Model: Mojito	Date: 26-Apr-00	No.: MA293001a
---------------	-----------------	----------------

MB Correction

Modified Article: Parts Catalog Correction		Prepared by: A. Sasaki	
From: Technical Services Dept., GTS Division			
Reason for Modification:	☒ Parts catalog correction	☐ Vendor change	☐ To meet standards ()
	☐ To facilitate assembly	☐ To improve reliability	
	☐ Part standardization	☐ Other

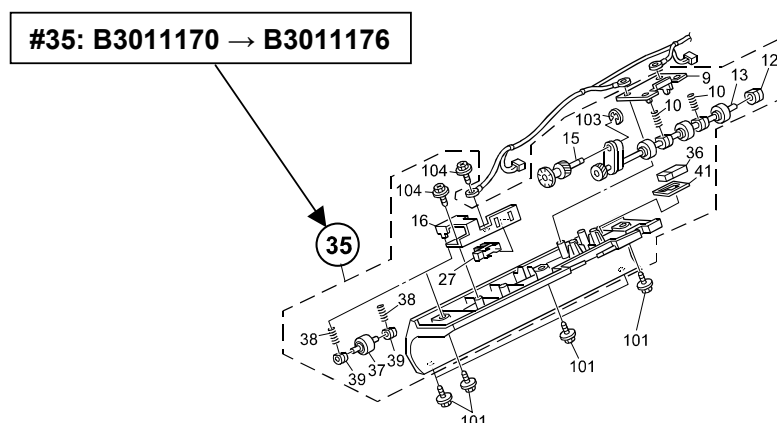
Part number	Description	Q'ty	Page	Index
Incorrect	B3011170	Paper Size Sensor Harness	1	23	35
Correct	B3011176	DC Harness	1	23	35

Section 6. ORIGINAL FEED SECTION 2 (A292/A293/B098)

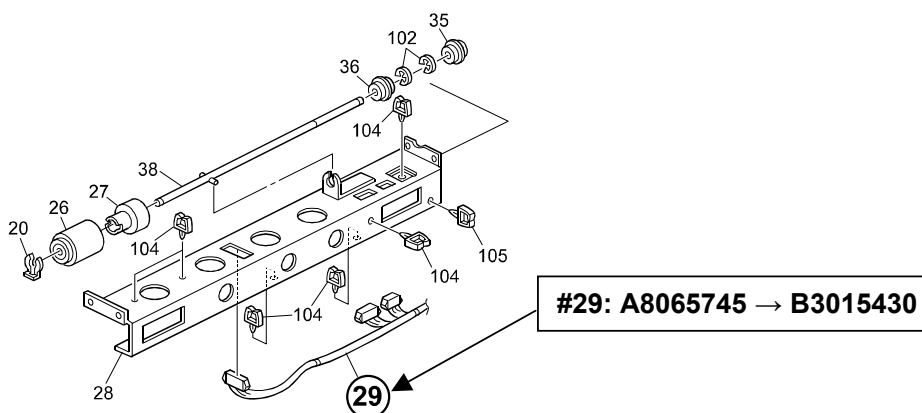
Part number	Description	Q'ty	Page	Index
Incorrect	A8065745	Paper Size Sensor Harness	1	25	29
Correct	B3015430	DC Harness	1	25	29

Section 7. ORIGINAL FEED SECTION 3 (A292/A293/B098)

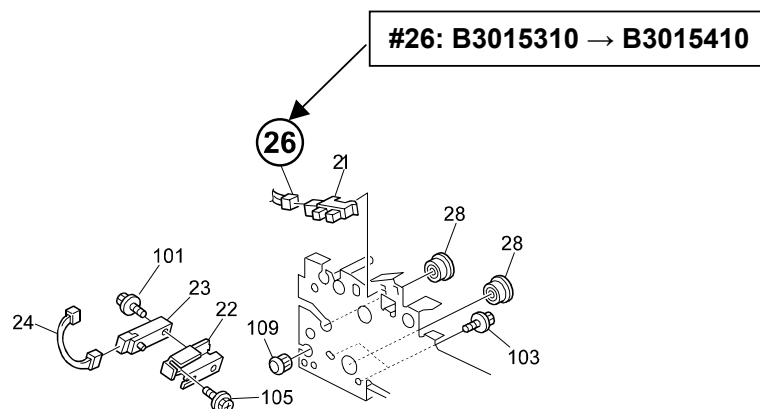
Part number	Description	Q'ty	Page	Index
Incorrect	B3015310	DC Relay Harness	1	27	26
Correct	B3015410	Harness: Connecting: Paper Feed	1	27	26

Section 7. ORIGINAL FEED SECTION 3 (A292/A293/B098)

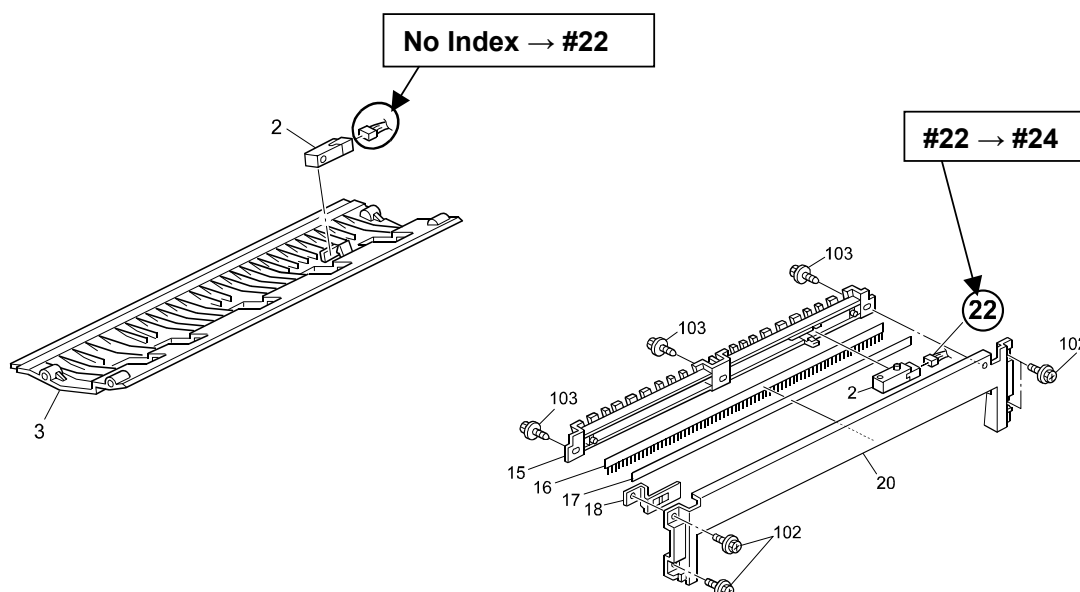
Part number	Description	Q'ty	Page	Index
Incorrect	B3015455	DC Relay Harness	1	31	22
Correct	B3015455	DC Relay Harness	1	31	22
	B3015460	DC Relay Harness	1	31	*24

Section 12. ARDF DRIVE & ELECTRICAL 2 (A292/A293/B098)

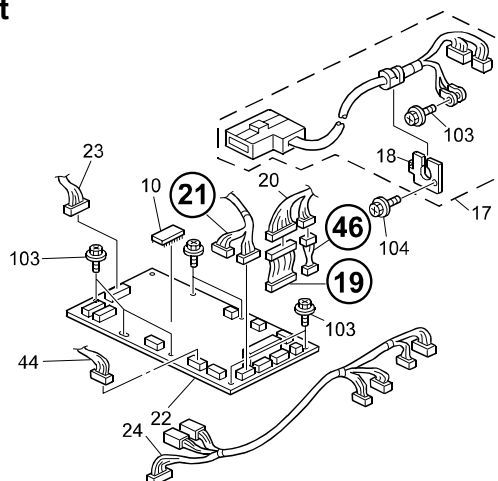
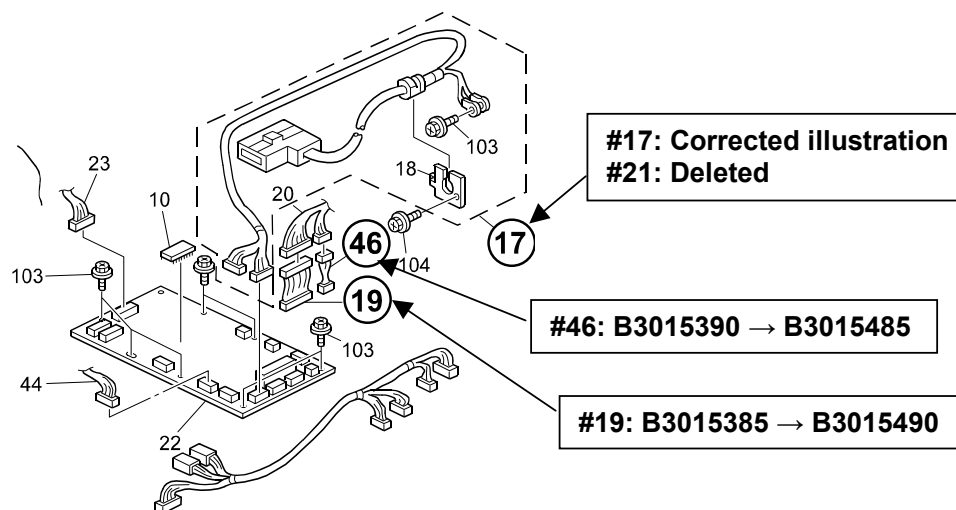
Part number	Description	Q'ty	Page	Index
Incorrect	B3015385	Relay Harness	1	37	19
	B3015430	DC Harness	1	37	21
	B3015390	Relay Harness	1	37	46
Correct	B3015340	DF Harness	1	37	17
	B3015490	Harness: Connecting: Sensor: Base	1	37	19
	B3015485	Harness: Connecting: Spring Clutch	1	37	46

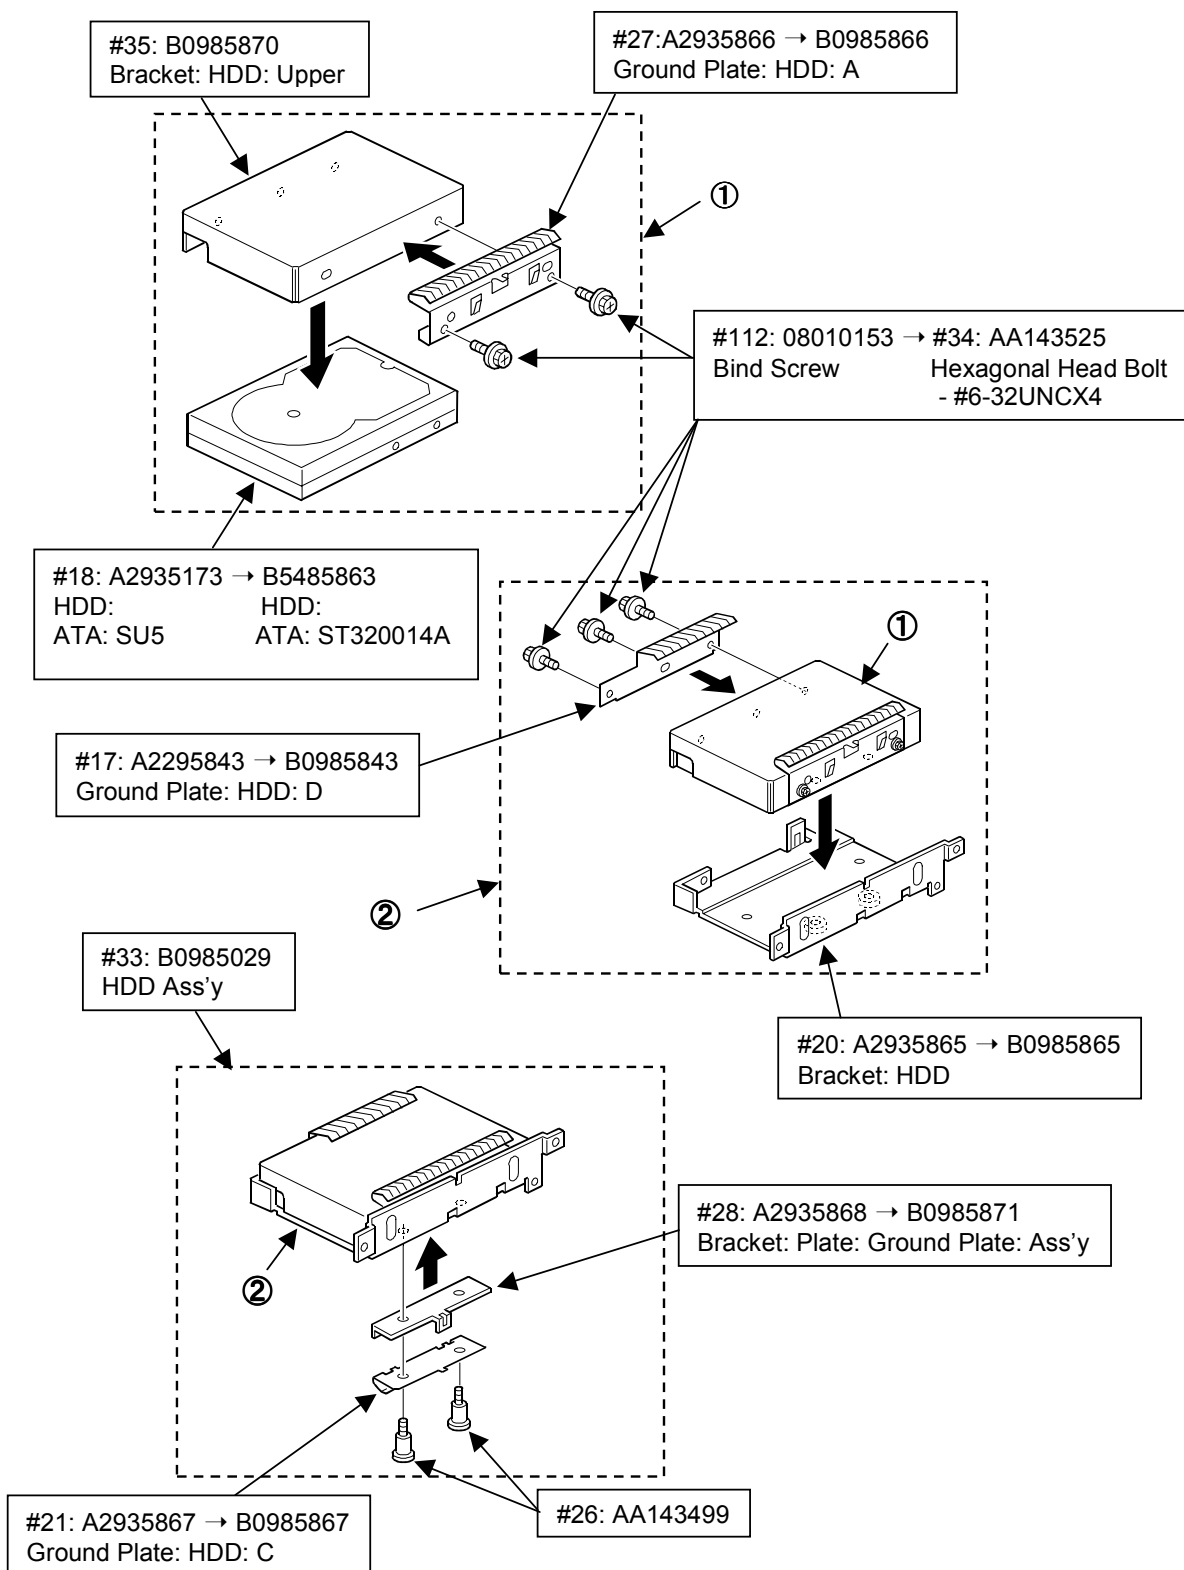
The HDD has been changed due to a vendor change.

Note: When installing the new HDD for the first time, it is necessary to install the newly registered HDD Assembly below to ensure compliance with electrical standards.

Old part number	New part number	Description	Q'ty	Int	Page	Index	Note
	B0985029	HDD Ass'y	0 - 1	-	135	*33	
A2295843		HDD Ground Plate	1 - 1	X/X	135	17	
	B0985843	Ground Plate: HDD: D					
A2945173		HDD: ATA: SU5	1 - 1	X/X	135	18	
	B5485863	HDD: ATA: ST320014A					
A2935865		HDD Bracket	1 - 1	X/X	135	20	
	B0985865	Bracket: HDD					
A2935867		HDD Ground Plate - C	1 - 1	X/X	135	21	
	B0985867	Ground Plate: HDD: C					
A2935866		HDD Ground Plate - A	1 - 1	X/X	135	27	
	B0985866	Ground Plate: HDD: A					
A2935868		Ground Plate Bracket	1 - 1	X/X	135	28	
	B0985871	Bracket: Plate: Ground Plate: Ass'y					
08010153		Bind Screw	n - n-5	X/X	135	112	
	AA143525	Hexagonal Head Bolt - #6-32UNCX4	0 - 5			*34	
	B0985870	Bracket: HDD: Upper	0 - 1	-	135	*35

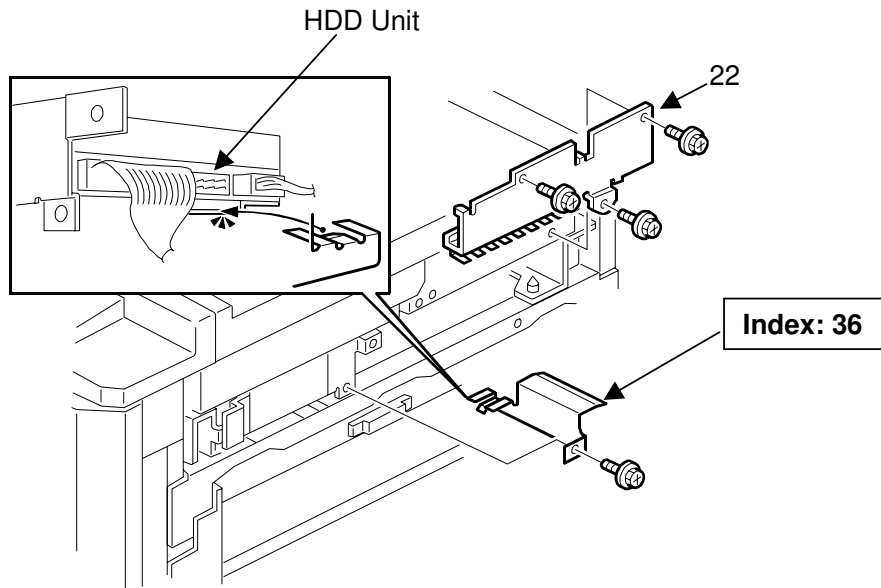
The following plate has been added to provide further protection for the MCU harness.

New part number	Description	Q'ty	Page	Index	Note
B0985875	Plate: Harness: MCU	0 - 1	135	36	*

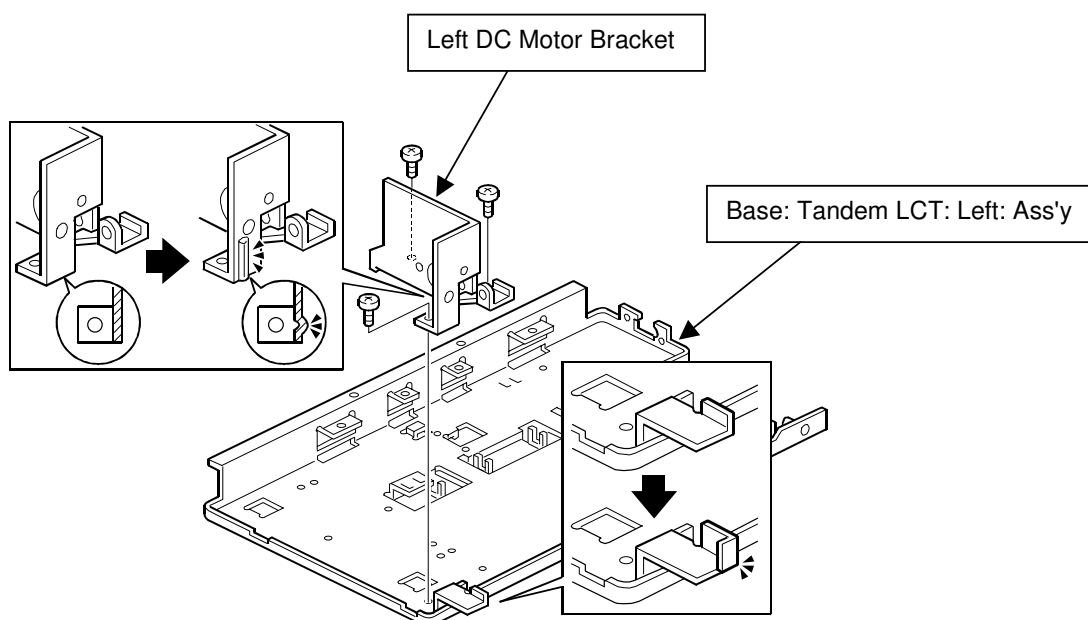
The following changes have been made to further provide for accurate side-to-side positioning of the tandem LCT.

- A bead has been added to the DC motor bracket
- The shape of the side-to-side positioning stopper has been changed

Note: When replacing the Motor Bracket or Tandem LCT Base, be sure to install both **together as a set**.
